Reference Number:
RZ042100-PCG-COM-0004 (Revision B)

Dominica Geothermal Risk Mitigation Project Contract

Subject: Bid Document Addendum 0004 – bridge required near IP/650 (Revision B)

18/024/01 SHT C01

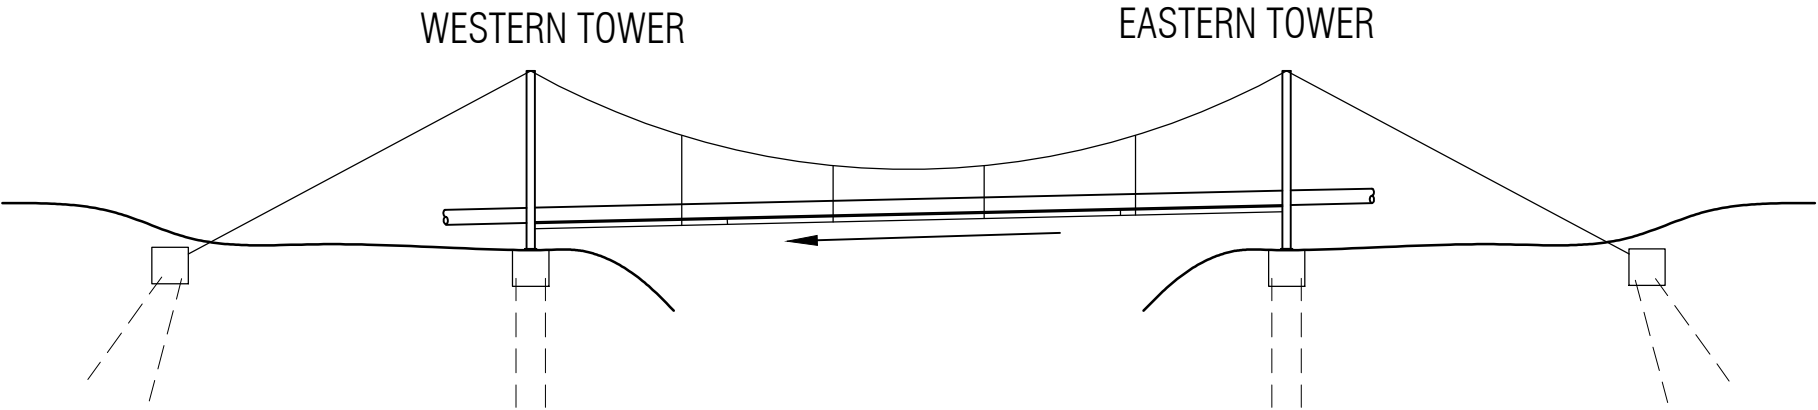
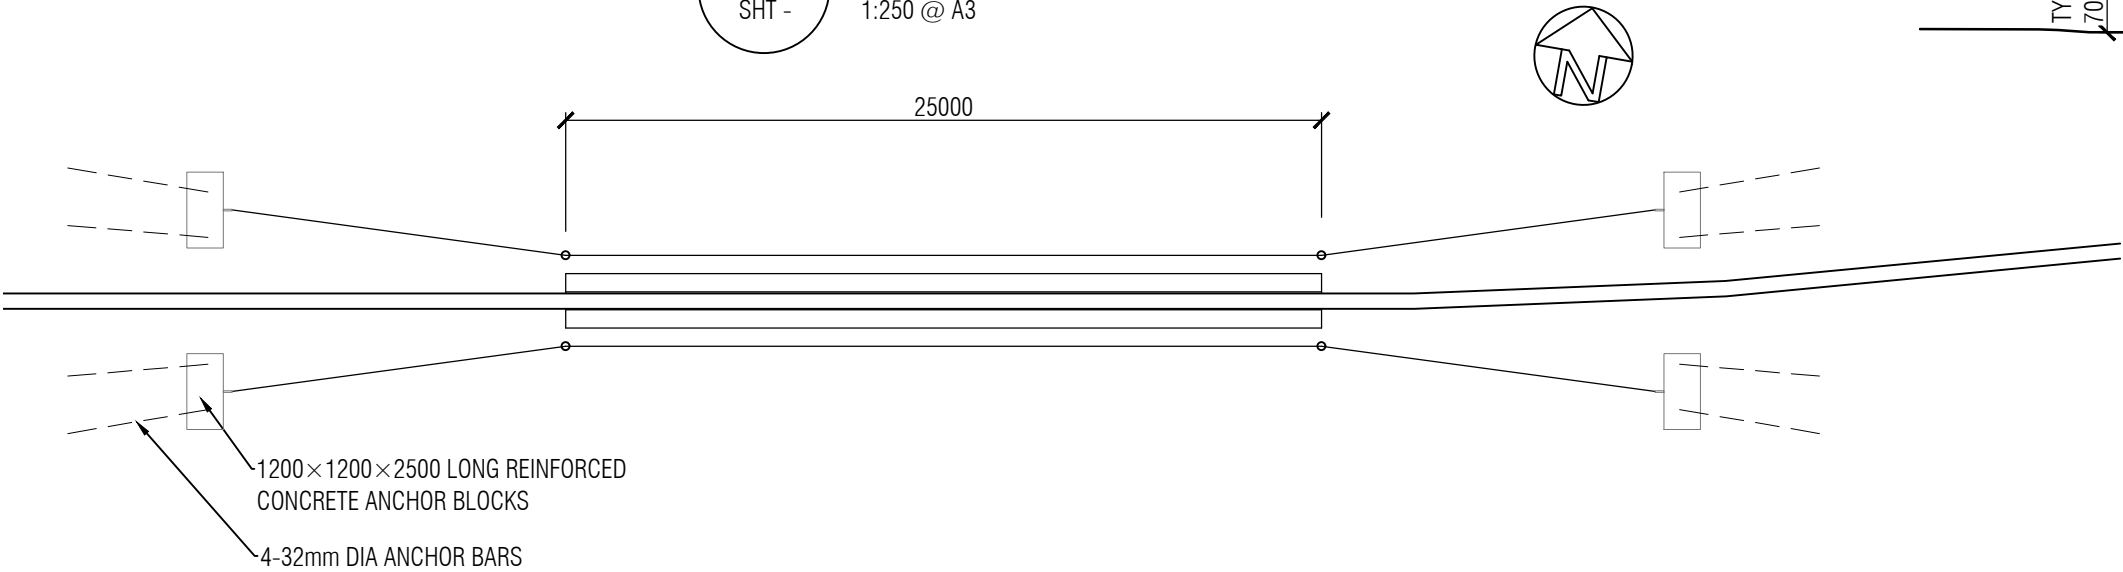
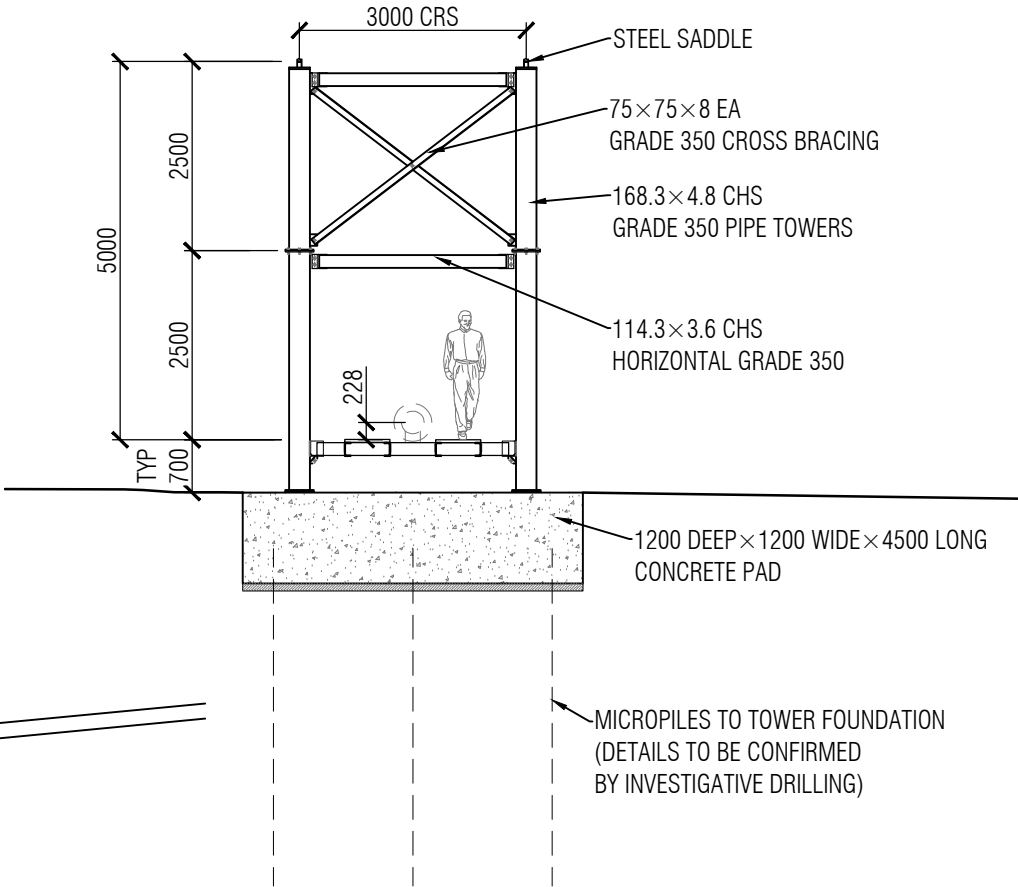
There is a requirement for an additional pipe bridge on the reinjection pipeline in the area of IP/650. This bridge is required to address a recent land slip at this location. The bridge is required to support the reinjection pipeline at the slip location and to provide pipeline protection from future rock falls.

Item	Description	Code ¹		Qty. (1)	Unit Price ²		Total Price ² (1) x (3)
					(2)	CIP (3)	
2.1.9.6	Slip bridge / suspension bridge (refer to dwgs 18/024/01 SHT C01 & 18/024/01 SHT C02)

Item	Description	Qty.	Unit Price ¹		Total Price ¹	
			Foreign Currency Portion	Local Currency Portion	Foreign	Local
		(1)	(2)	(3)	(1) x (2)	(1) x (3)
4.15	Provide installation and other services for the slip bridge / suspension bridge (refer to dwgs 18/024/01 SHT C01 & 18/024/01 SHT C02)

- 3) Include the following drawings as attached to Part 2, Section VII, item 1. Drawings:
- 18/024/01 SHT C01
 - 18/024/01 SHT C02

4.12.7 Slip Bridge

In the region of IP/650, the Contractor shall provide a reliable, economic and easily serviced bridge structure to enable the reinjection pipeline to span over an existing slip / unstable hillside of approximately 25m in length. This bridge shall be designed and constructed together with the Gorge Pipe Bridge described in Section 4.12.1.

The previous general Gorge Pipe Bridge requirements from section 4.12.2 to 4.12.6 shall be adapted and applied to this Slip Bridge.
